RS-02-100

Subject: Revision to Technical Specifications Change Request – Clarification of Requirements for Licensed Operator Qualifications and Training

**SUBJECT: Revision to Technical Specifications Change Request – Clarification
of Requirements for Licensed Operator Qualifications and Training**

5.0-5

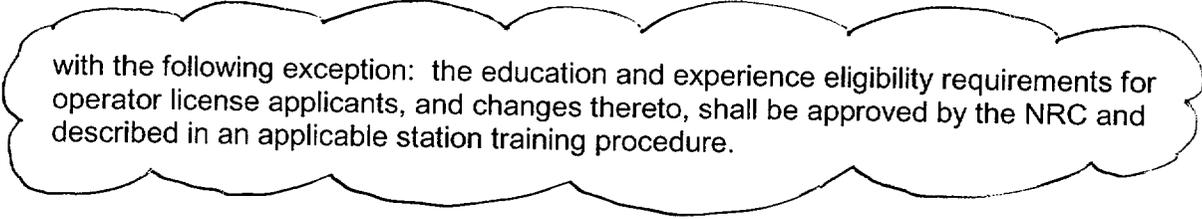
5.3.1 Each member of the unit staff shall meet or exceed the minimum qualifications of ANSI/ANS 3.1-1978, ~~as modified by Specification 5.2.2.f.~~

with the following exception: the education and experience eligibility requirements for operator license applicants, and changes thereto, shall be approved by the NRC and described in an applicable station training procedure.
